SUBJECT: Revised Plan for Z2019-04 dated 3.20.19

RE: Application for Rezoning - Zoning Case No.: Z2019-04
(Legistar No. 20190009)

REZONING APPLICATION ANALYSIS**ZONING CASE #:** Z2019-04**LEGISTAR:** 20190009**LANDOWNERS:**

EXHIBIT C - APPLICATION

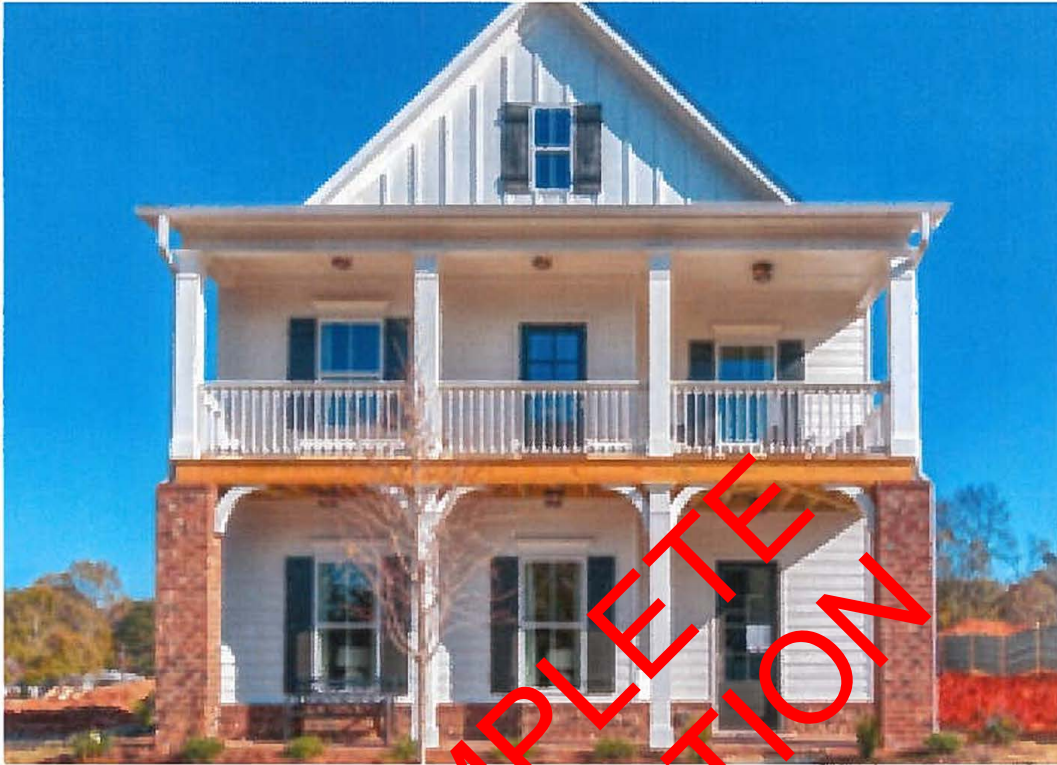
Substantially Similar to the "elevations?" (Stipulation# 3 incorporated by reference) Incorporate a downloaded photo of a building that's under construction?

**IS THIS DOWNLOADED PHOTO "ELEVATION"
SUB- STANTIALLY-SIMILAR?**

Is this substantially similar to what will be built within a development that will have 900 square foot townhouses with no active amenities? Incorporate by reference?
